# 15 Belsize Park Gardens 2015/3426/P

Delegated Report (Members Briefing)		Analysis sheet		Expiry Date:	15/09/2015		
		N/A		Consultation Expiry Date:	20/08/2015		
Officer Tessa Craig			Application Nu 2015/3426/P	imber(s)			
Application Address			Drawing Numb	Drawing Numbers			
15 Belsize Park Gardens London NW3 4JG			Design and Acc	Design and Access Statement, 003.15_S01 Revision P1 and 003.15_201 Revision P2.			
PO 3/4 Area Team Signature C&UD			Authorised Off	Authorised Officer Signature			
Proposal(s)							
Extension of existing rear roof terrace and installation of new balustrade.							
Recommendation(s): Grant Planning Permission			ission	on			
Application Type: Full Planning		ing Permiss	g Permission				
Conditions or Reasons for Refusal:	Refer to Draf	ft Decision No	otice				
Informatives:							
Consultations							
Adjoining Occupiers:	No. notified	67	No. of responses		objections	00	
	No. electronic <b>00</b> No objections have been received from neighbouring properties.

Extension of existing roof terrace and new balustrade.

View showing rear elevations along Belsize Gardens – site in red

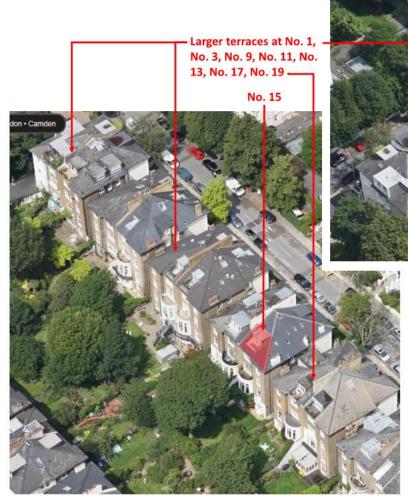
- 2.6 However it is considered that the principle and detail of the terrace is acceptable here. In this case, the roofscape has already been significantly altered by a variety of dormers and roof terraces including ones that extend to the roof edge. Officers have noted from aerial photos that, within this group of properties on the south side of Belsize Park Road, 40 properties have an altered rear roofslope in some way including rooflights, dormers and roof terraces; 27 of these properties include roof terraces with 21 appearing to extend out to the roof edge. The applicant's

submitted photos also show that, out of 10 semi-detached properties here, 6 already have terraces that extend out to the roof edge which do not comply with CPG advice (see attached photos). Therefore it is considered there is a significant number and established pattern of roof terraces that extend to the edge of the roof. Although most of the nearby examples are historic and predate current LDF policy and CPG guidance, it is considered the character of this roofscape has been changed and that the addition of the extended terrace at the subject site would not further significantly harm the character of this area and its roofscape and that it would not set an unwelcome precedent. The terrace would match the width of the dormer and would still appear as a subservient feature here. Furthermore, the railings would not be visible from the streetscene and the wrought iron railings would be sympathetic to the main property and match adjoining ones.
